**NOTICE OF PROPOSED AMENDMENT (NPA) No 21/2005**

**on Certification Specifications, including airworthiness codes and acceptable means of  
compliance, for Large Aeroplanes (CS-25)**

**“FUEL TANK STRUCTURAL INTEGRITY / FUEL TANK ACCESS COVERS”**

**Figure 3- Example of Distances For Fuel Forward Acting Design Pressure Calculations**

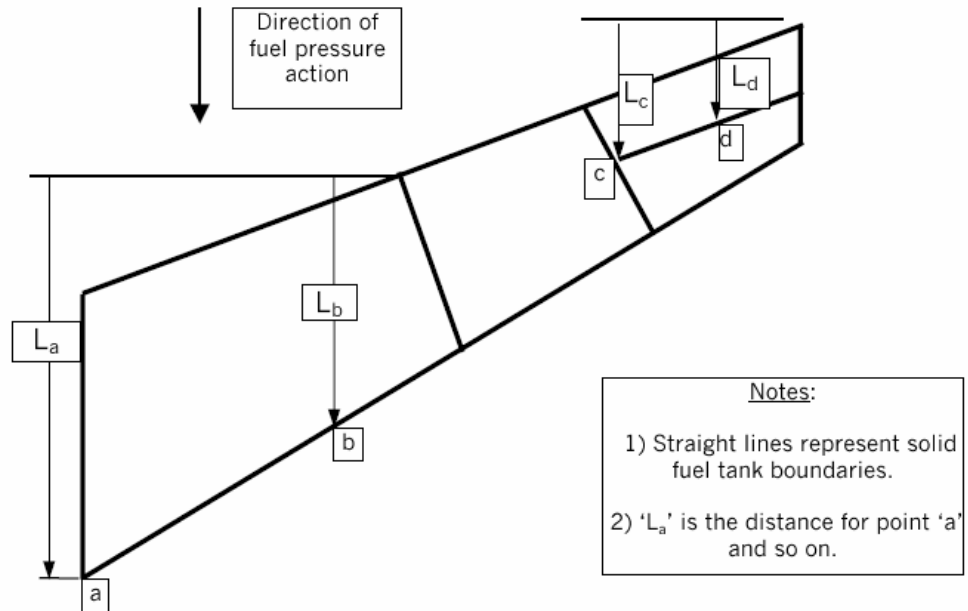
The equation for fuel tank pressure uses a factor L, based upon fuel tank geometry. Figure 3 shows examples of the way L is calculated for fuel pressures arising in the forward loading condition, while Figure 4 shows examples for fuel pressures arising in the outboard loading condition. For Jet A(-1) fuel, a typical density of 785.0 kg/m<sup>3</sup> (6.55 lb/US gallon) may be assumed.
